TOWN OF CORTLANDT PLANNING BOARD

Planning Board Work Session & Meeting Tuesday July 7, 2026

b. **PB 2025-7 Yeshiva New Dormitory & Campus Upgrades**

Application of the Yeshiva Ohr Hameir for Site Plan approval, an amended Special Permit for a University, College or Seminary and for Wetland and Tree Removal Permits for a proposed 51,730 sq. ft. dormitory building, a 1,640 sq. ft. storage building, the repurposing of other buildings on site, and site improvements including stormwater, landscaping and building façade renovations located at the existing Yeshiva Ohr Hameir campus at 141 Furnace Woods Rd. Drawings revised June 12, 2026. (see prior PB 7-09)

SITE PLAN

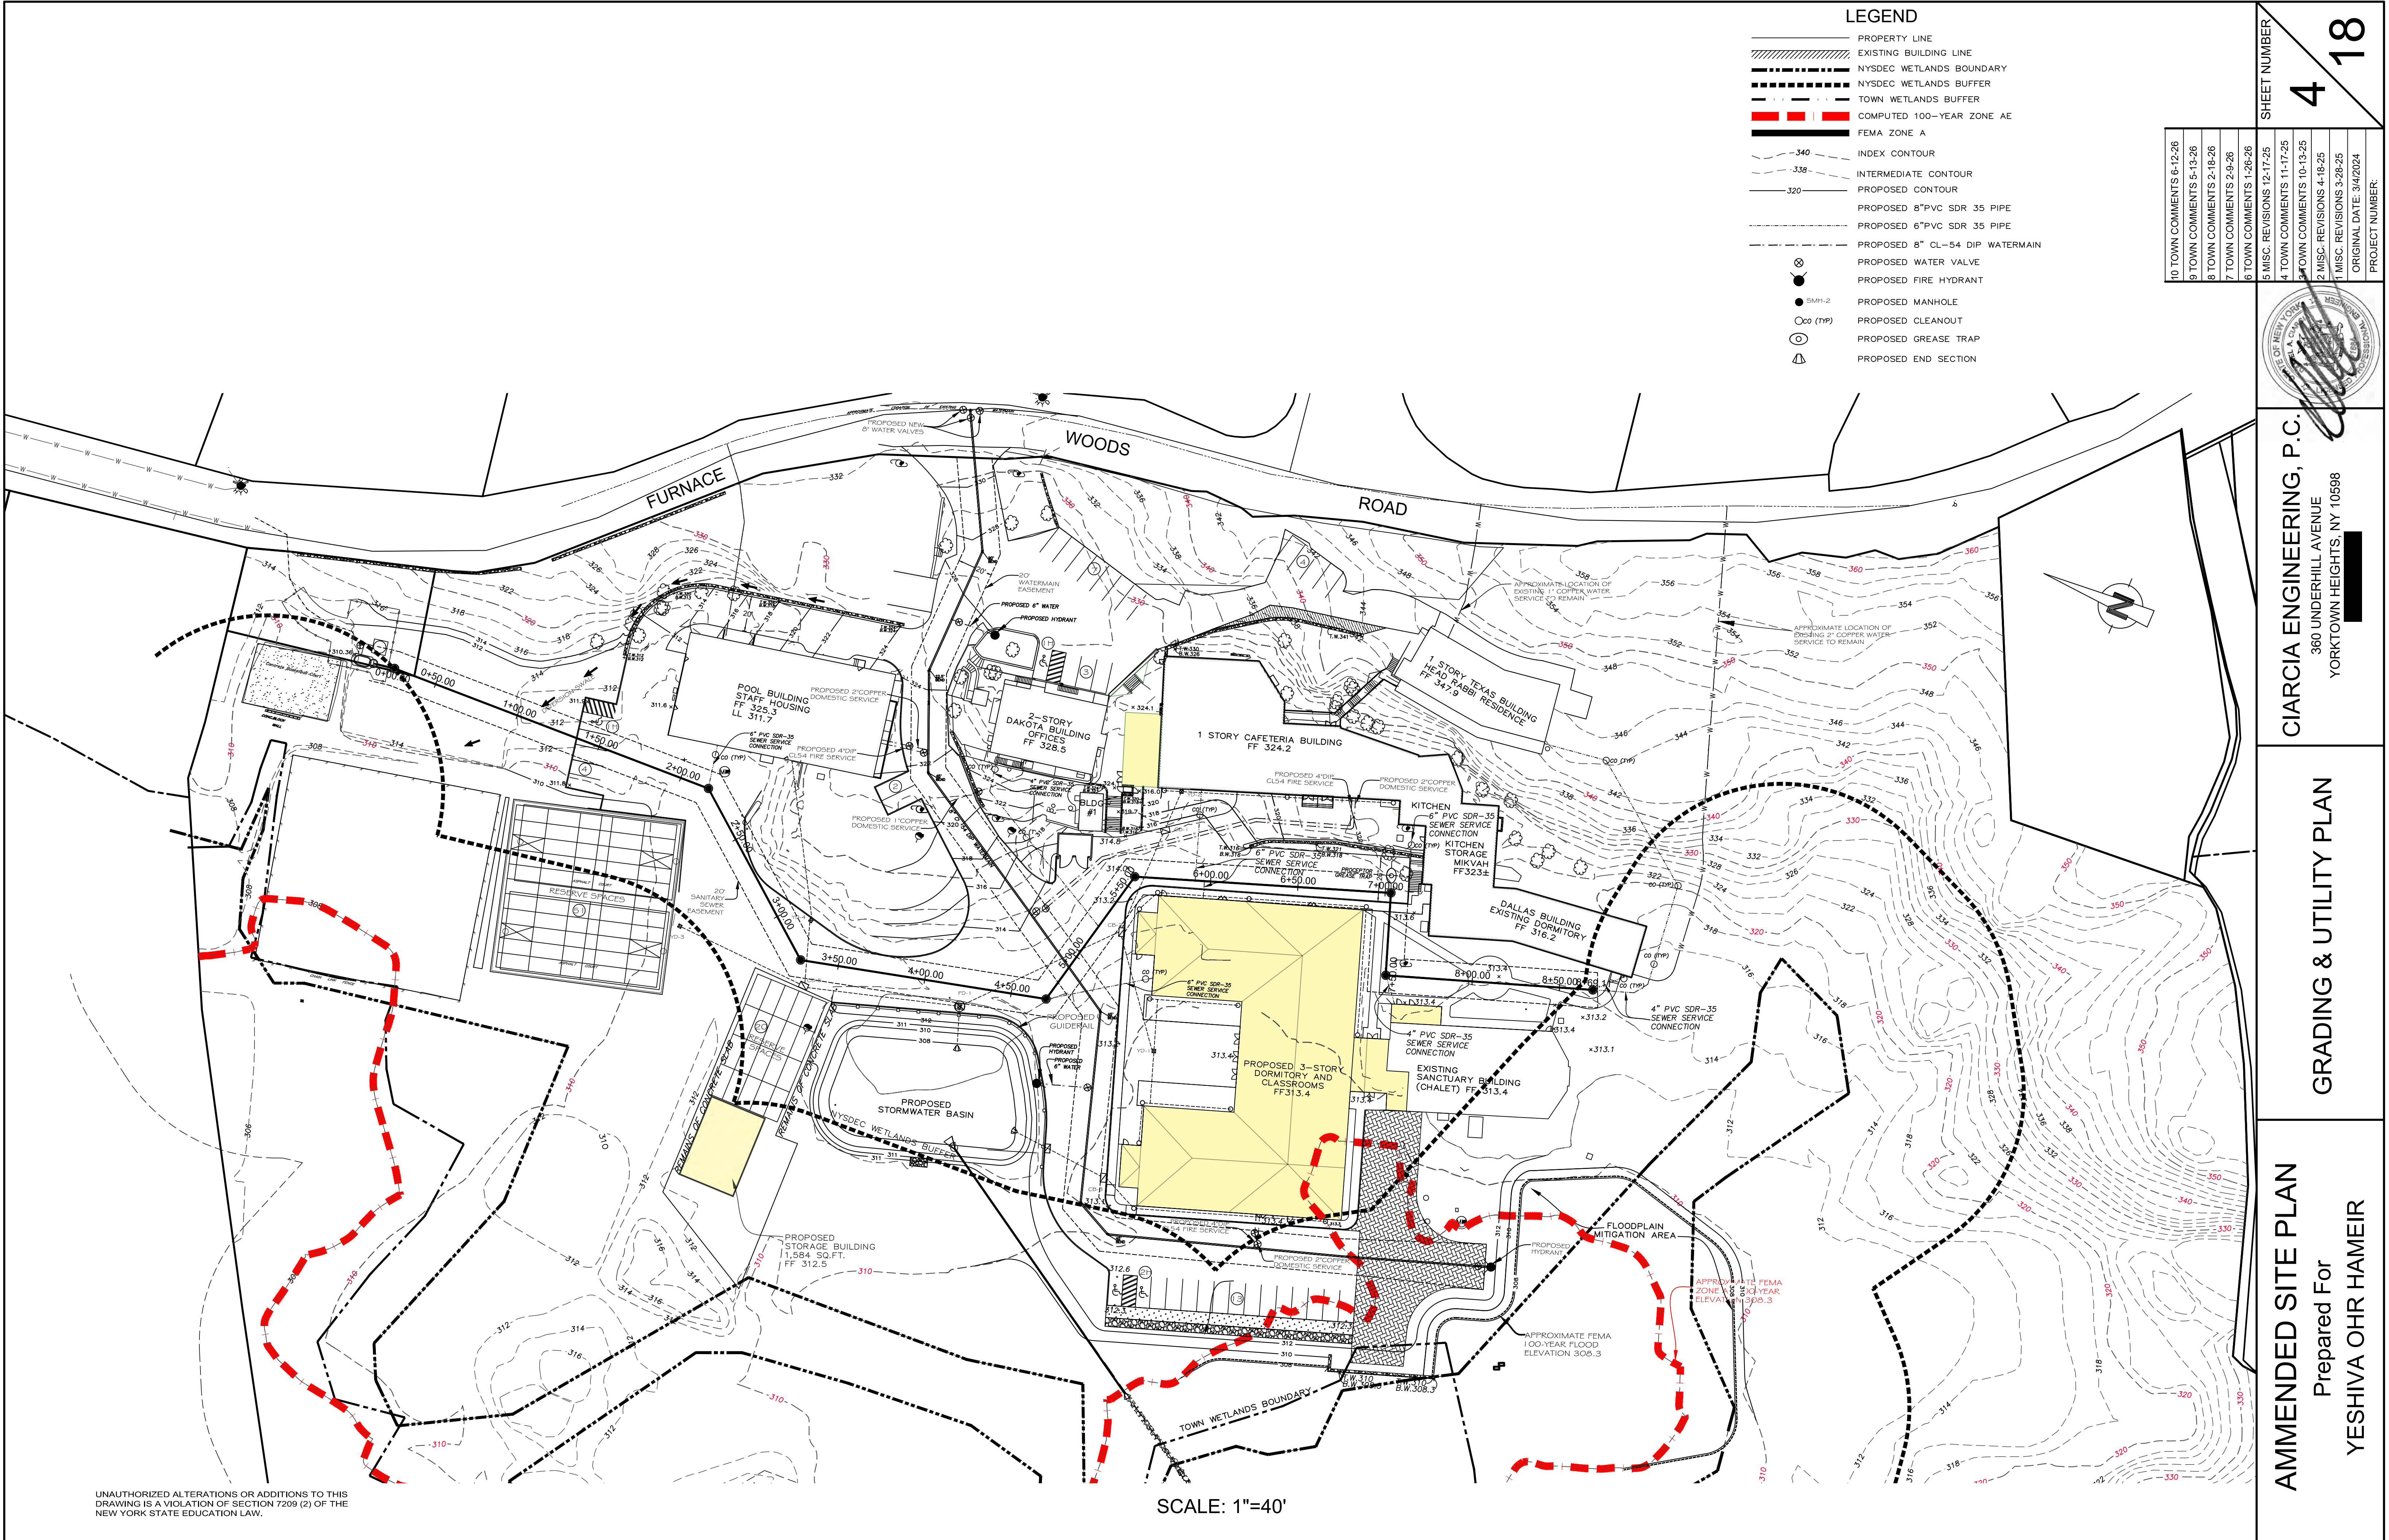
Sheet 3 – Site Plan

Response 1: A table has been added to the Site Plan (Sheet 3) demonstrating that the floodplain mitigation requirement has been met. The proposed project displaces 5,607 cubic feet of the 100-year floodplain. The mitigation area provides 7,290 cubic feet of storage.

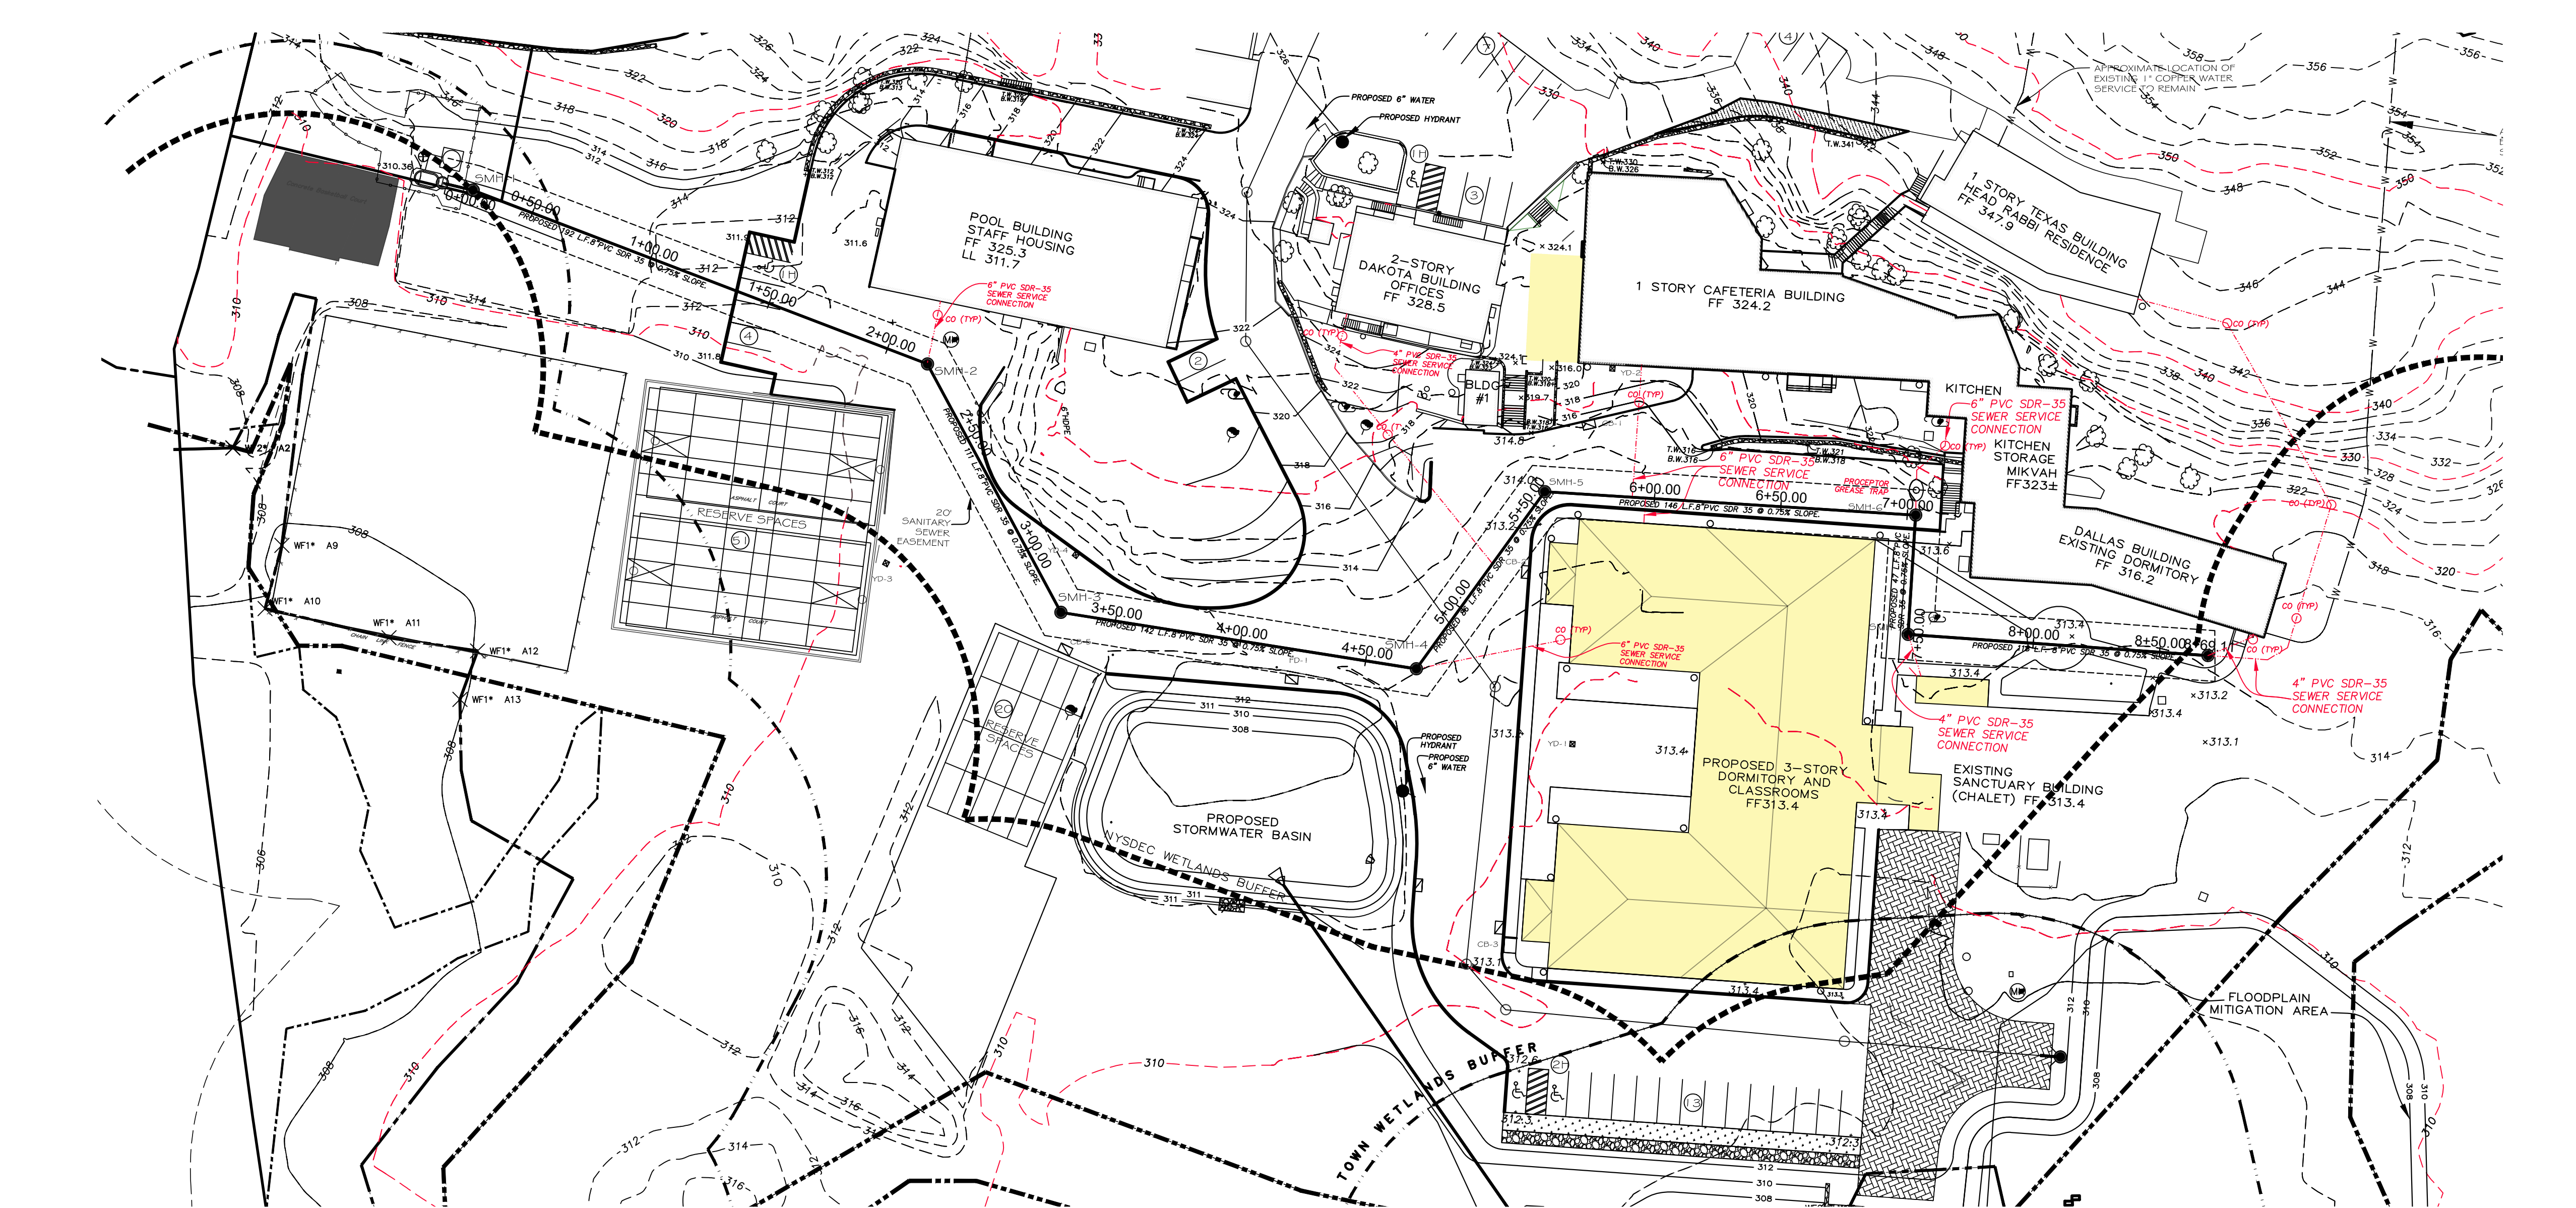
Comment 2: Sheet 6 of 15 – Label the station and elevation of each crossing in the profile.

Comment 3: Sheet 6 of 15 – Provide stationing and invert connections of all lateral connections along the proposed new sanitary line.

WATERMAIN INSTALLATION STANDARDS

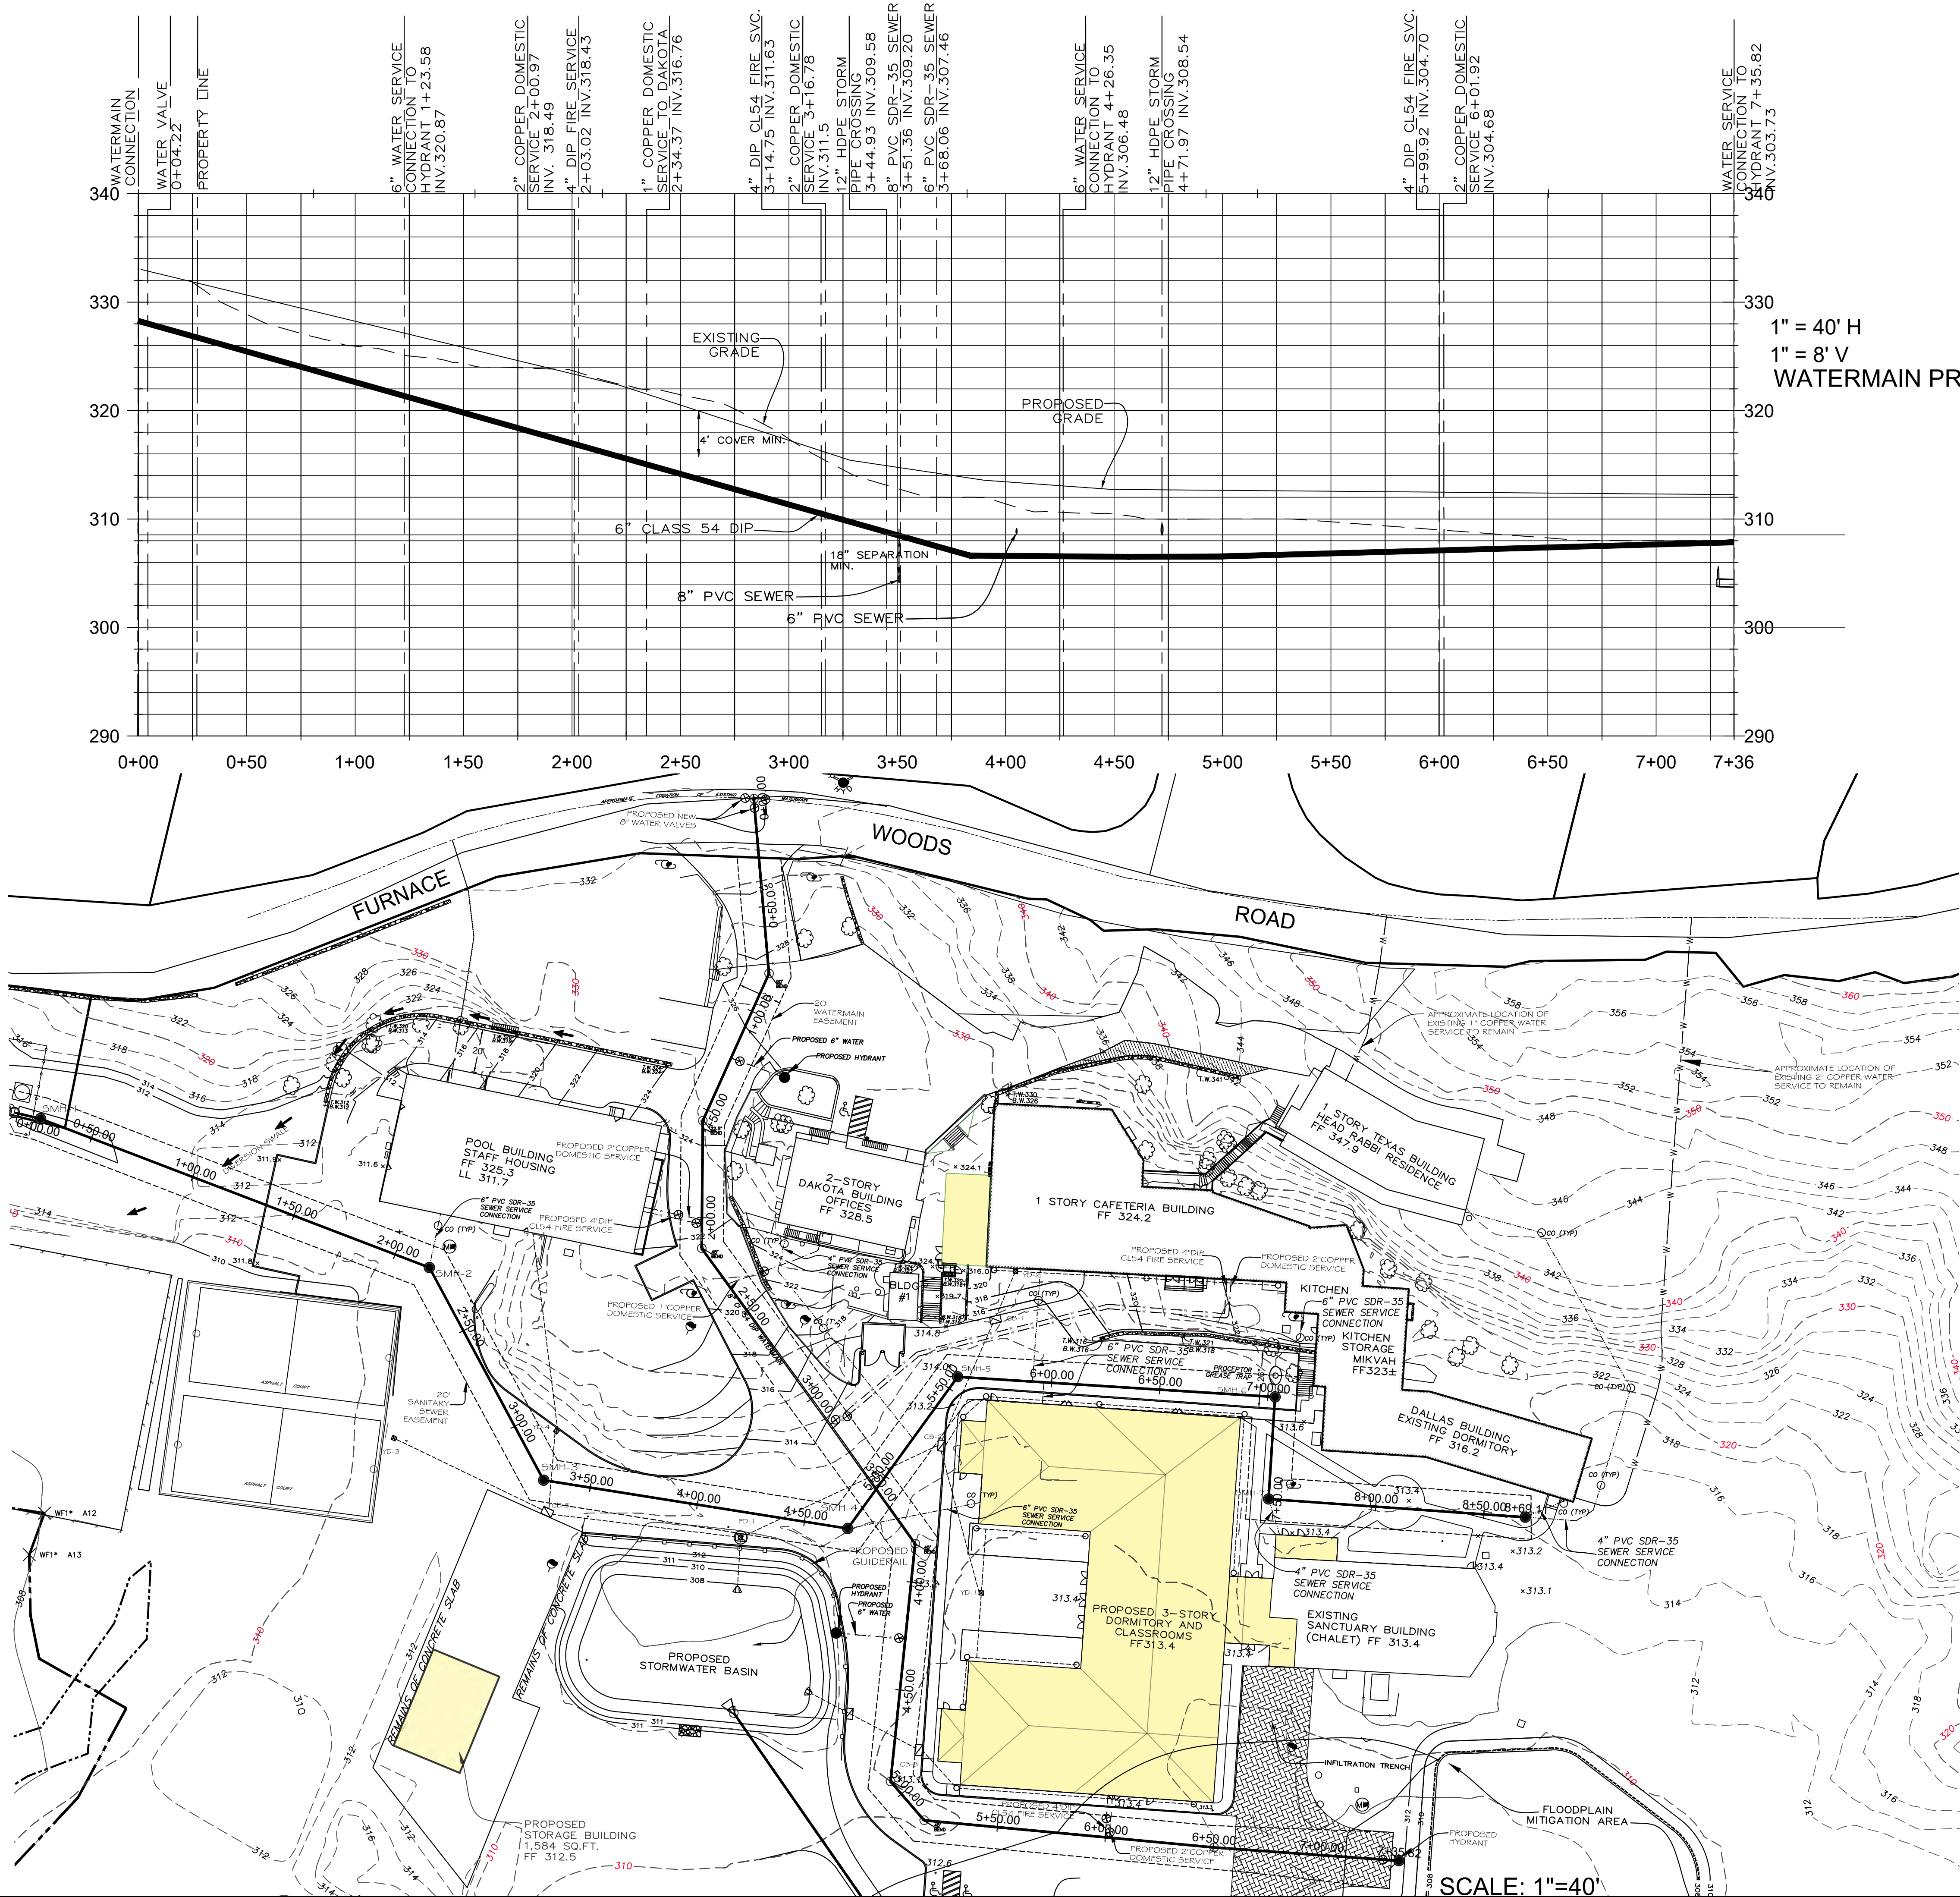
Comment 4 Sheet 7 of 15 – A 2-inch domestic feed to the dormitory is proposed. As the building will be designed to accommodate 320 students, confirm the adequacy of the domestic service. Also, confirm the adequacy if 4-inch service with Project Architect/MEP to accommodate fire service. The response indicates the pipes will be sized by the MEP. As the DOTS

Response 4: The notes have been added to the watermain installation standards on sheet 13.
